Access Compliance Report Public Rights-of-Way (Curb Ramps)

Main Street: REDBERRY_RD		Cross Street: RANCHWOOD_RD		Location:	SE
ADA ID: RPAT211013144355	Ramp Type: Type 3 - Combination 1	Initial Pass/Fail: Pass	Overall Compliance: No	Severity Score:	0
Codes/Mitigation Info/Possible Solution			Field Measurements/Component Compliance

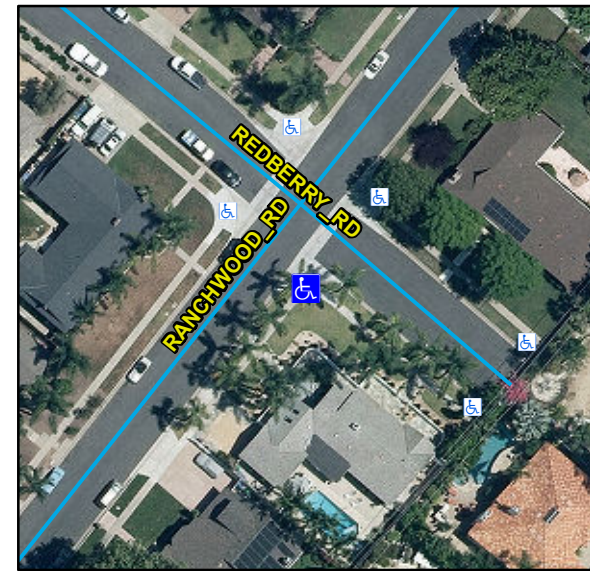
Remove & Replace Curb Slope. Remove & Replace Sidewalk.
